Industry/TSTF Standard Technical Specification Change Traveler

Risk Informed Evaluation of Extensions to Containment Isolation Valve Completion Times (WCAP-15791)

NUREGs Affected: 1430 1431 1432 1433 1434

LCO 3.6.3 Containment Isolation Valves (Atmospheric, Subatmospheric, Ice Condenser, and Dual)

Containment Isolation Valves (Atmospheric, Subatmospheric, Ice Condenser, and Dual)
3.6.3

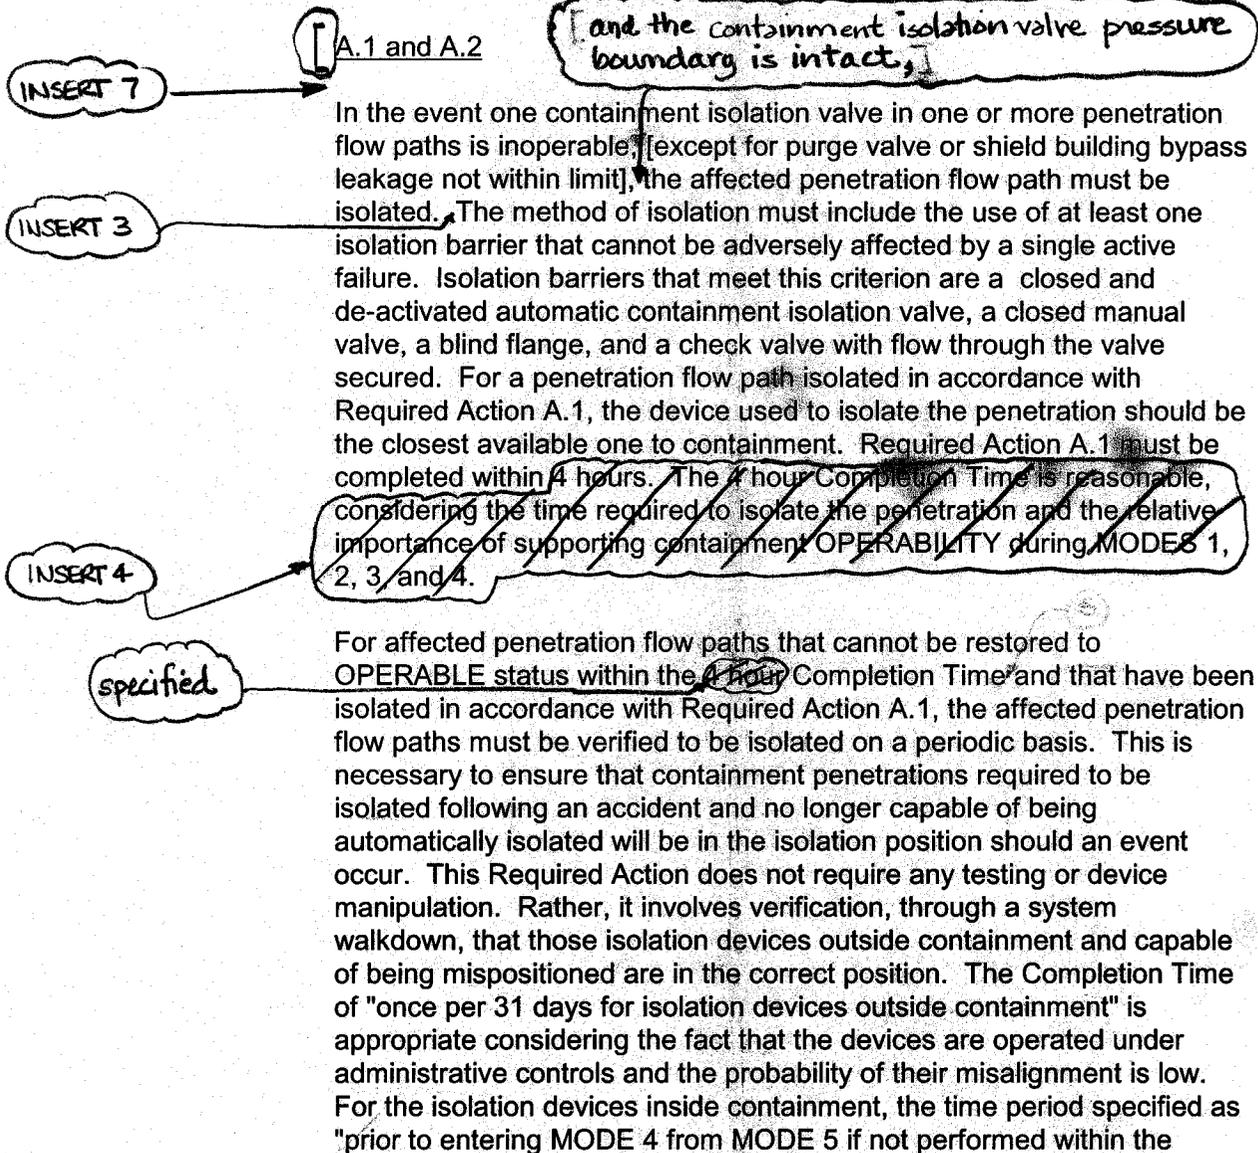
C. → E

E.1
C.

| CONDITION | REQUIRED ACTION | COMPLETION TIME |
|---|--|---|
| <p>D. [One or more shield building bypass leakage [or purge valve leakage] not within limit.</p> | <p>D.1 Restore leakage within limit.</p> | <p>4 hours for shield building bypass leakage</p> <p><u>AND</u></p> <p>24 hours for purge valve leakage]</p> |
| <p>E. [One or more penetration flow paths with one or more containment purge valves not within purge valve leakage limits.</p> | <p>E.1 Isolate the affected penetration flow path by use of at least one [closed and de-activated automatic valve, closed manual valve, or blind flange].</p> <p><u>AND</u></p> | <p>24 hours</p> |
